**CEC, INC. ADDENDUM #1**

**GREENSBURG SALEM SCHOOL DISTRICT  
HVAC UPGRADES AT THREE SCHOOLS  
GREENSBURG, PENNSYLVANIA 15601  
CITY OF GREENSBURG, WESTMORELAND COUNTY**

**CEC Project 327-839.0009**

**October 6, 2023**

**1 METZGAR MECHANICAL FIRST FLOOR DEMOLITION PLAN**  
 M-1101 3/32" = 1' 0"

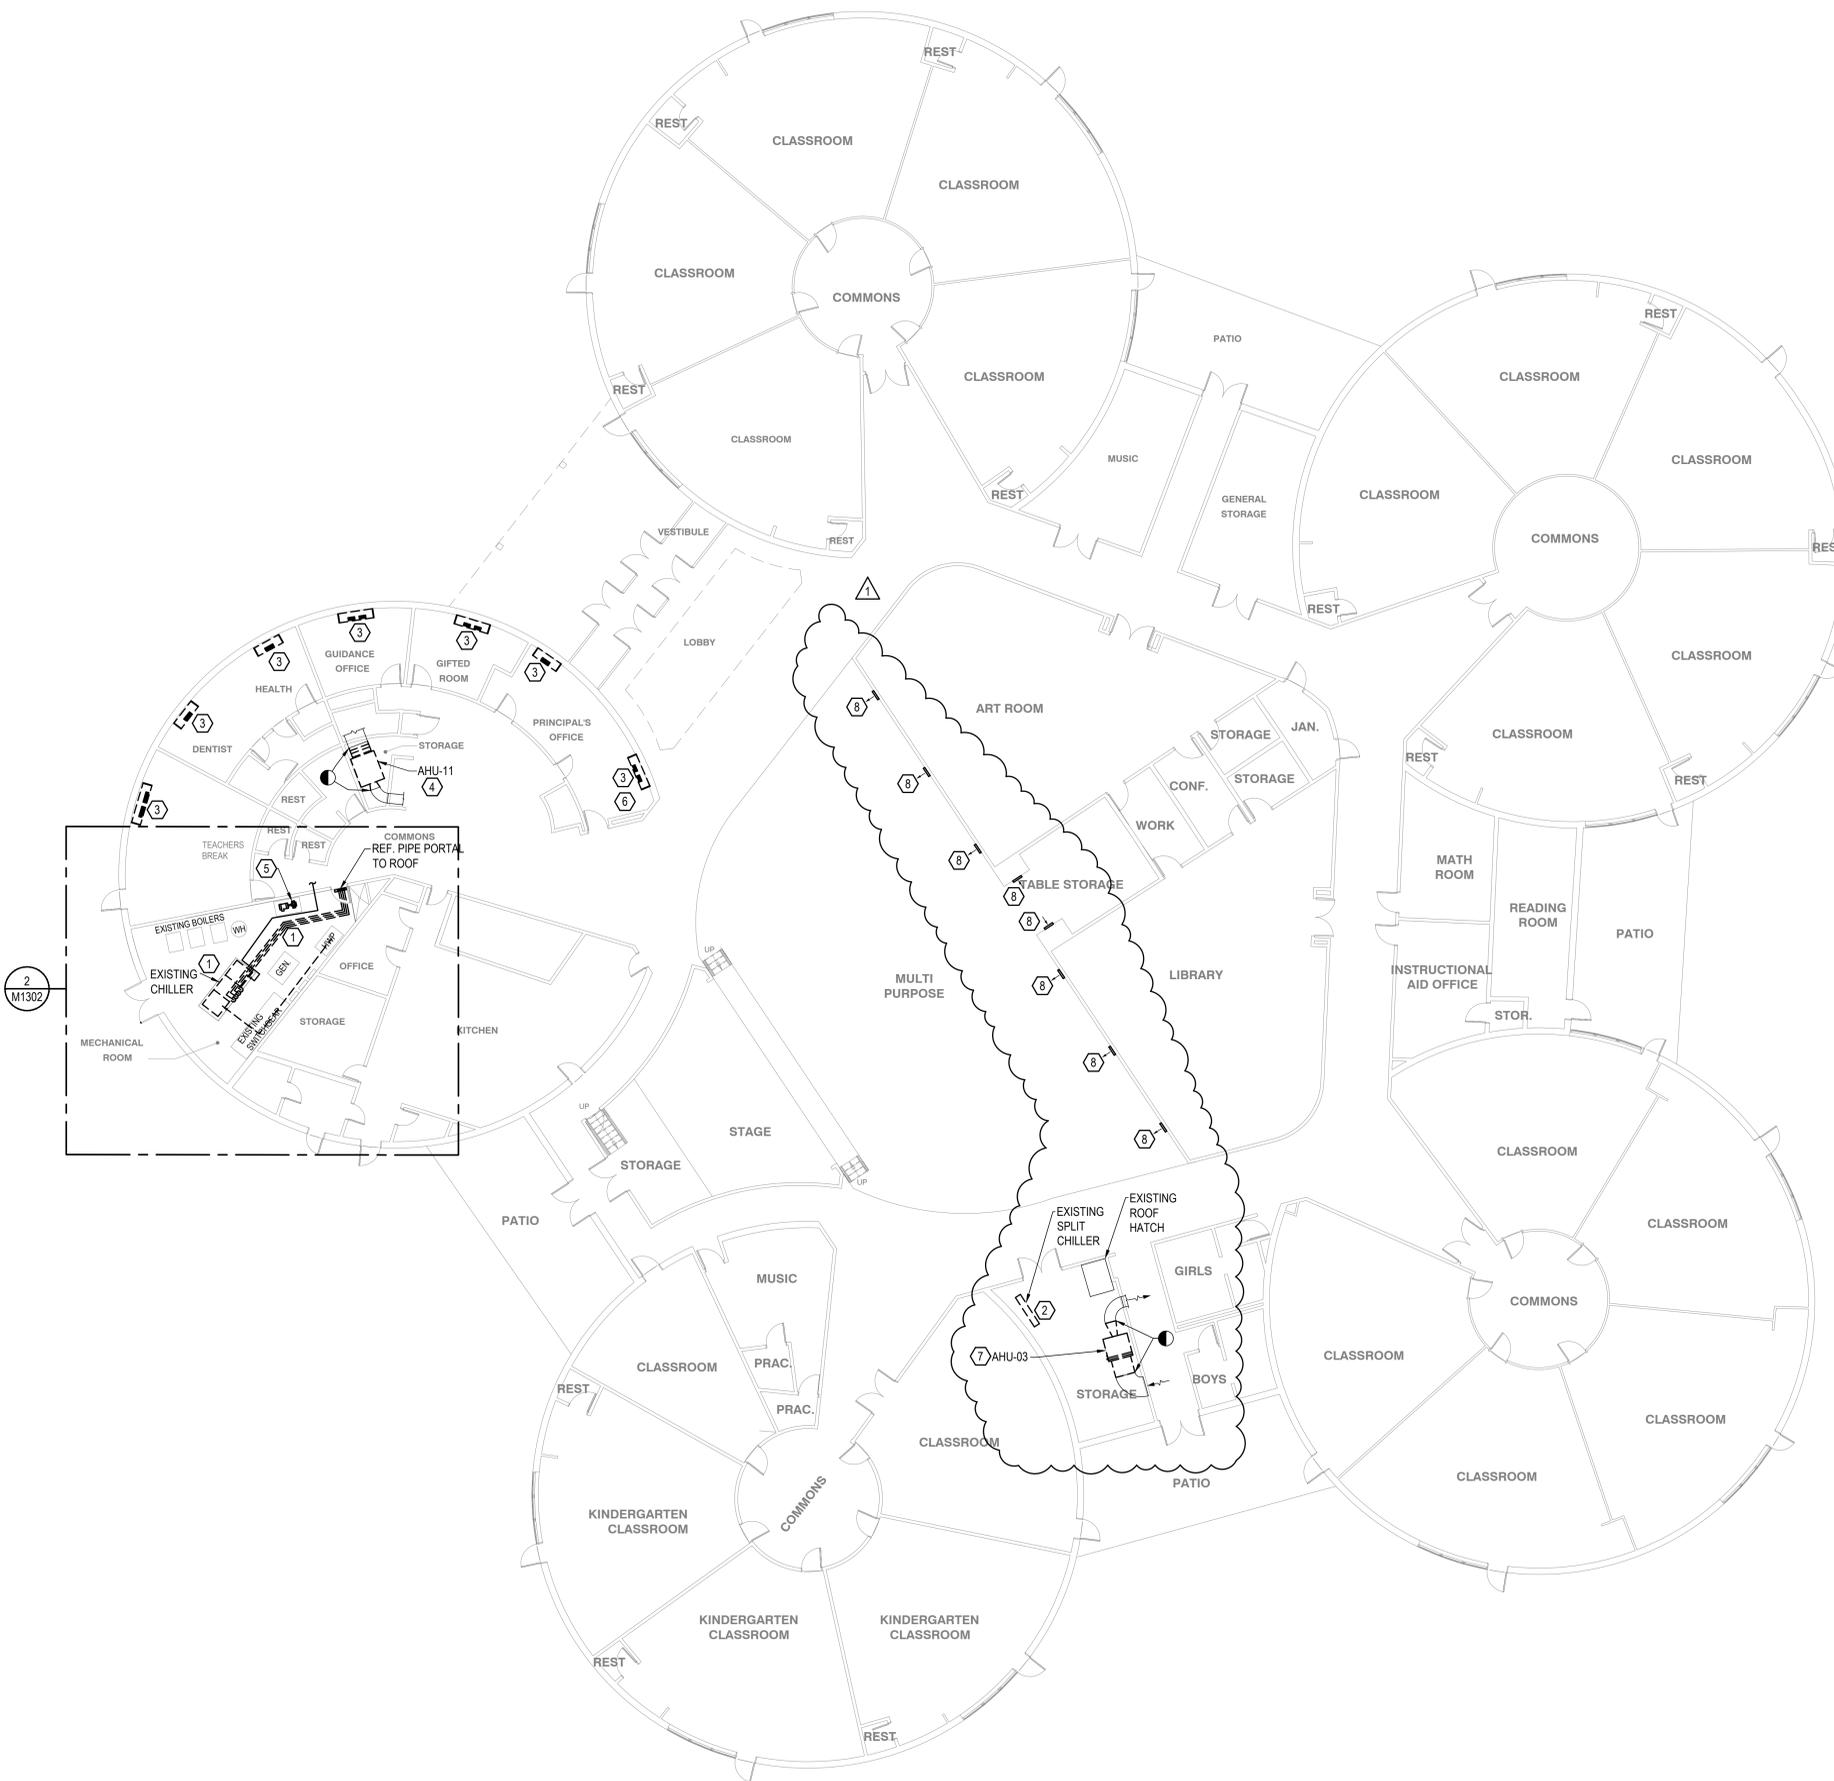
3. M1101/2101 note 3 indicates to minimize demolition at the units. M1201/2201 note 2 states to reuse existing. Please provide a better/more descriptive outline for the work in these areas.

**CEC Response: The 1101/2101 note is intended to instruct to only demolish what is necessary to remove the existing UV. The 1201/2201 is to reuse whatever was not demolished to reconnect the new units. Patch in piping as needed to tie in new units. The intention was not to do a wholesale demolition of all of the piping and to leave the riser pipe that is embedded in the walls for reuse. The supply and return horizontal piping above the ceiling was to be demolished as it would be oriented incorrectly for the new piping.**

1 METZGAR MECHANICAL FIRST FLOOR PLAN  
 M-1201 3/32" = 1' 0"

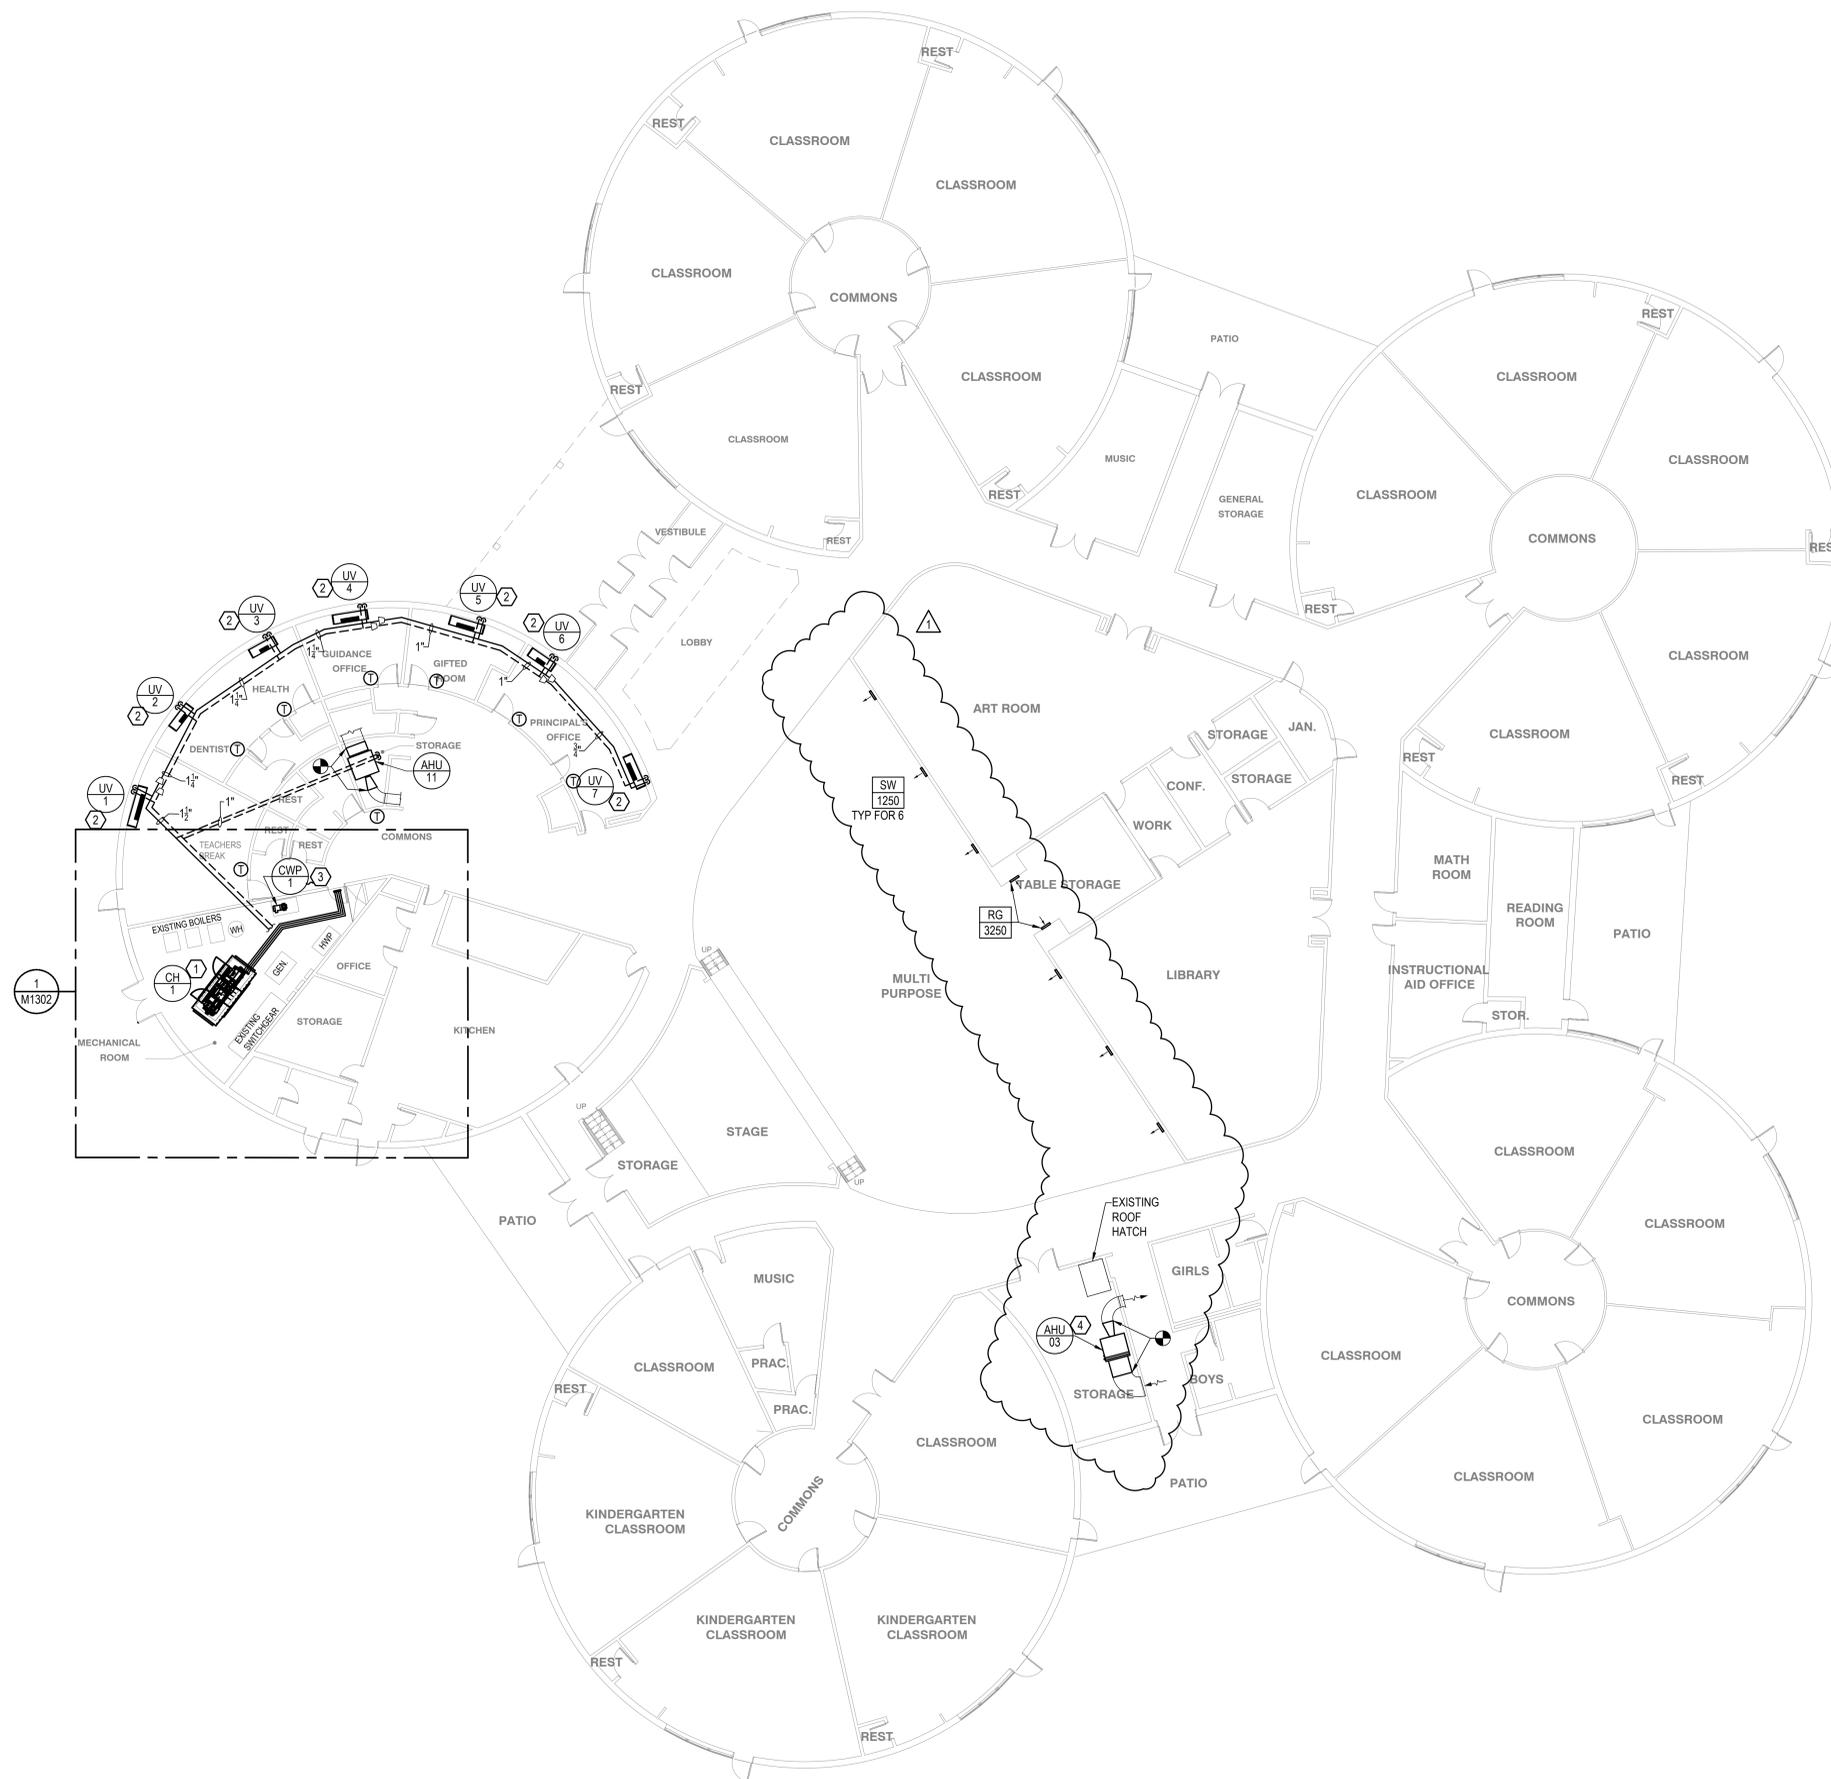
7. Will the existing chiller pad need to be modified?  
**CEC Response: The existing chiller pad should not need to be modified. The basis of design chiller will fit on the existing pad. The sound enclosure should fit the outside of the pad.**

1. INSTALL NEW CHILLER ON EXISTING HOUSEKEEPING PAD. JUSTIFY TO THE SIDE OF THE PAD OPPOSITE OF THE SWITCHGEAR. SOUND ENCLOSURE SHOULD GO AROUND ENTIRE CHILLER AND HOUSEKEEPING PAD SECURED TO FLOOR.
2. INSTALL NEW UNIT HEATERS IN THE SAME LOCATION AS THE DEMOLISHED UNIT. REUSE THE PIPING CONNECTIONS AND ELECTRICAL CONNECTIONS. CONNECT THE NEW PIPING TO THE EXISTING PIPING IN THE WALL THAT FEEDS THE UNITS. ASSUME THE "CONNECT TO EXISTING" SYMBOL IS AT ALL PIPING CONNECTIONS.
3. INSTALL NEW CHILLED WATER PUMP. INSTALL NEW PUMP TRIM PER PUMP DETAIL. SEE DETAIL SHEET. SEE ALSO, ENLARGED MECHANICAL ROOM PLAN.
4. INSTALL NEW AHU-03. INSTALL PIPING TO RECONNECT AHU TO EXISTING HOT WATER PIPING. INSTALL DUCT TRANSITIONS AS NEEDED TO RECONNECT TO EXISTING DUCT SYSTEMS. INSTALL NEW CONTROLS AND SENSORS INTO NEW UNIT. THIS WORK IS ASSOCIATED WITH THE ADD-ALTERNATE WORK SCOPE.

3 END SUCTION, BASE MOUNTED PUMP DETAIL  
M2301 NONE

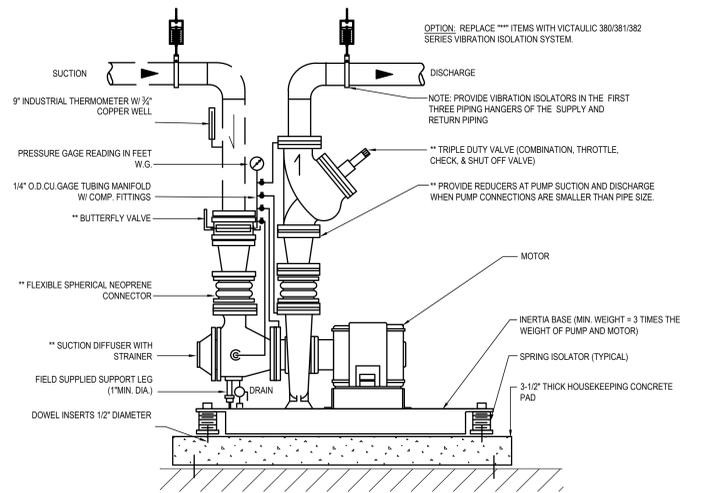
6. Detail # M1301/2301 indicate the pump pad is new. However, the demo drawings do not indicate the pads are to be removed. Please clarify.  
**CEC Response: The existing pump pad is to be reused.**
